Woollahra Local Planning Panel (Public Meeting)

LOCAL PLANNING PANEL DEVELOPMENT APPLICATION ASSESSMENT REPORT

THAT the Woollahra Local Planning Panel, exercising the functions of Council, as the consent authority, refuse development consent to Development Application No. 413/2023/1 for extensive alterations and additions (New Dwelling) including a new swimming pool and associated landscaping on land at 90 John Street Woollahra, for the following reasons:

Figure 11: Looking south from the main living area of No.14 Ocean Street, Woollahra toward the subject site (Author).

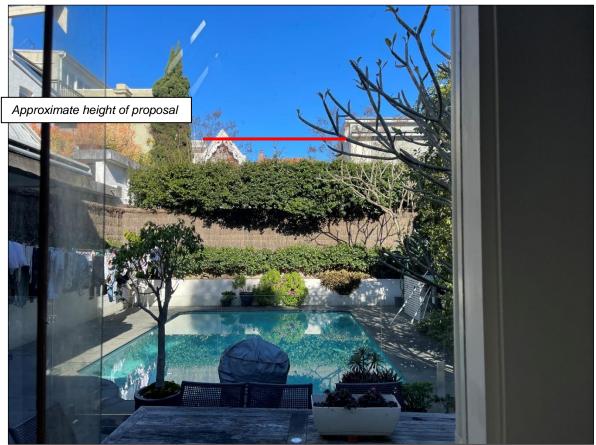
- Although screened, the windows at both ground and first floor levels (DW13, DW14, DW22, DW23 and DW24) have the capacity to result in unreasonable privacy impact to the main living area and private open space of No.14 Ocean Street. In the absence of the existing hedge or any proposed landscaping (as per the planning principle established in Super Studio v Waverley [2004]), there would be limited privacy between the two properties (C6).

Figure: Diagrams indicating areas of overlooking into No.88 John Street (Author).

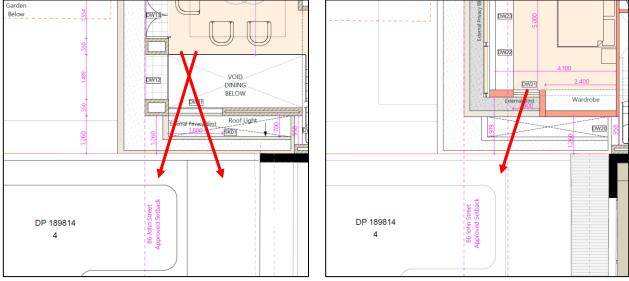
One Objection was received in relation to proposed windows to the western elevation (DW11 and DW21) and the northern elevation at the western side of the dwelling (DW10 and DW20), and their overlooking impact to the property at 88 John Street. DW10 and DW20 in this instance are located to the stair well of the proposed dwelling and would therefore not be considered to result in any adverse visual privacy impacts.

• In relation to DW11, whilst it is acknowledged that there is a void area of just under 2m between the dining area and the window, the trafficable area of this level is still in close proximity to and would still have a direct sightline into the private open space and pool area located at No. 88 John Street. Notwithstanding the proposed screening to these windows, the proposal would provide unreasonable overlooking into the main private open space area of No.88 John Street which is non-compliant with C6.

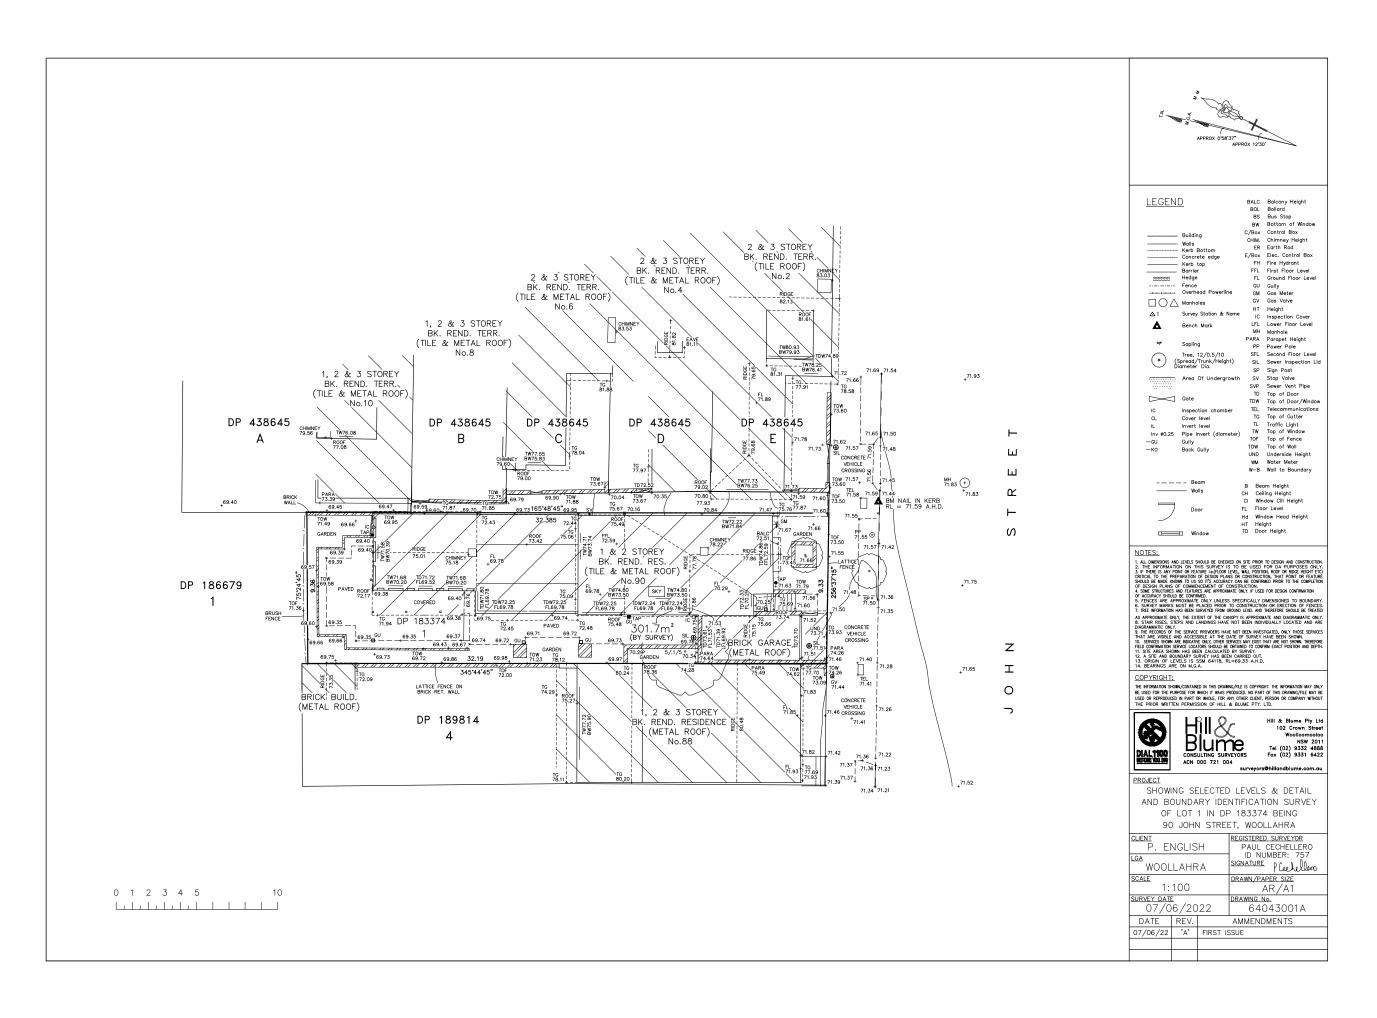
Drawing DA-04A.3 (Proposed Lower Ground Floor) includes the notation 'New timber boundary fence' to the eastern boundary at the rear which is discrepant with other drawings in the submitted set. This would require clarification.

Proiect	90 John Street, WOOLLAHRA
Drawing Name	Landscape Plan
Project Number	2206
Drawing No	DA-11.1

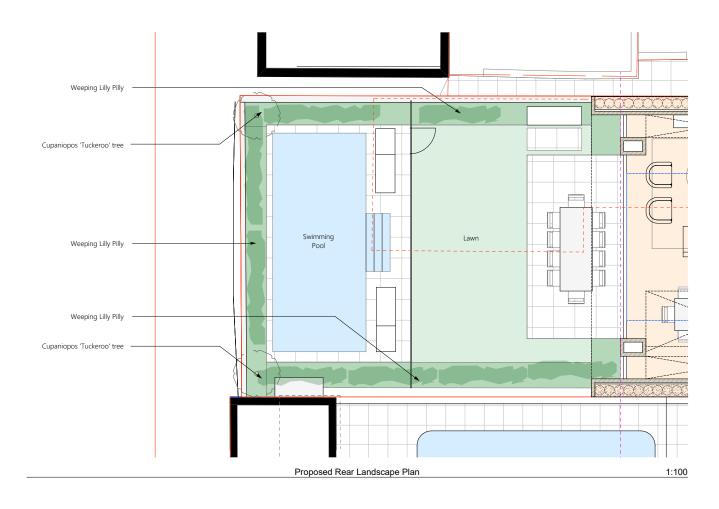
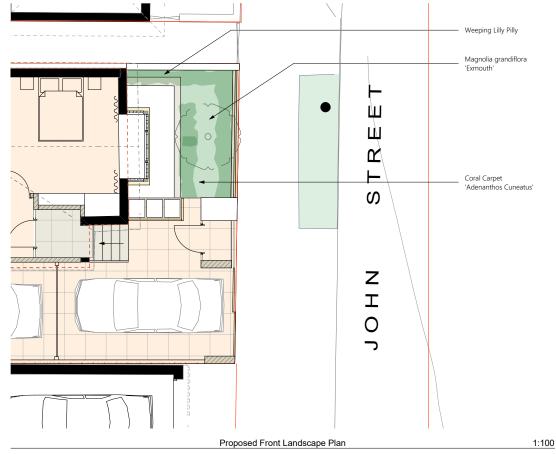
There is insufficient space provided for the Tuckeroo trees located either side of the swimming pool adjacent the rear boundary. These trees are unlikely to succeed as landscape features due to the small restricted area of deep soil provided in this location. Consequently there is a design modification required to ensure these trees are planted either side of the proposed lawn area to ensure they grow to their full potential and provide benefit to the site and neighbouring properties.

Inadequate soil area provided for the proposed Tuckeroo trees at the rear of the pool areamodification to the planting location required.

- a) The Landscape Plan must show the two (2) proposed Tuckeroo trees to be planted on either side of the lawn area and not within the planter bed area located either side and to the rear of the swimming pool.
- * This condition has been imposed to ensure the future growth potential and establishment of new tree plantings is maximised.
